Access Compliance Report

Public Rights-of-Way

Intersection ID: 43364	Main Street: PROSPERITY_VIEW_DR	Cross Street: HIGHLAND_COMMONS_RD	Location: N
ADA ID: F0970722C0F8	Ramp Type: BlendTrans1	Initial Pass/Fail: Pass	Overall Compliance: No
			Severity Score: 19.25

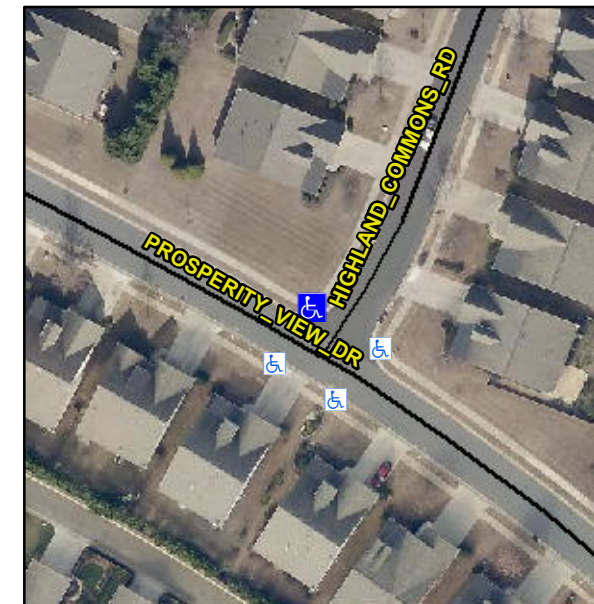
CURB GAP 2.0

Not Found, R304.5.3, R304.2.1, R305.2, R302.7.2

Compliance	Description	Data	Compliance	Description	Data
N/A	Ramp Length (in)	48.0	Yes	BlendTrans Slope (%)	5.0
Yes	Ramp Width (in)	50.0	No	BlendTrans XSlope (%)	2.9
N/A	Flare Type LT	Sloped	N/A	Flare Type RT	Sloped
N/A	Flare Slope LT (%)	2.6	N/A	Flare Slope RT (%)	3.9
N/A	Flare Traversable LT?	No	N/A	Flare Traversable RT?	No
No	Landing Length (in)	46.0	Yes	DWS Provided?	Yes
No	Landing Width (in)	39.0	Yes	DWS Contrast?	Yes
Yes	Landing Slope (%)	0.3	Yes	DWS Length (in)	25.5
No	Landing X Slope (%)	2.1	Yes	DWS Full Width?	Yes
N/A	Landing Curb? (Y/N)	No	No	DWS Offset (in)	2.5
N/A	Shared Landing?	No			
Yes	Gutter Ponding?	No	Yes	Gutter Slope (%)	1.4
No	Gutter Lip Ht (in)	1.0	Yes	Gutter X Slope (%)	0.3
N/A	Painted X Walk1?	No	N/A	Painted X Walk2?	No
	X Walk 1 Direction	To SW		X Walk 2 Direction	To SE
	X Walk 1 Width (in)	N/A		X Walk 2 Width (in)	N/A
	X Walk 1 Slope (%)	1.9		X Walk 2 Slope (%)	0.9
	X Walk 1 X Slope (%)	1.1		X Walk 2 X Slope (%)	0.9

N/A	Ramp inside XWalk1?	N/A	N/A	Ramp inside XWalk2?	N/A
	Road Slope (%)	2.2		Clear Space?	Yes
	Road X Slope (%)	0.8	N/A	Clear Space to XWalk (in)	N/A
Yes	Any Obstructions?	No	Yes	Storm Grate/Utility Hazard?	No
	Obstruction Type			Storm Grate/Utility Type	
		N/A			N/A
			Yes	Surface Condition? (G/P)	Good
			No	Curb Slope (%)	12.8

Remove & Replace Curb Ramp With Two New Directional Ramps or Equivalent.
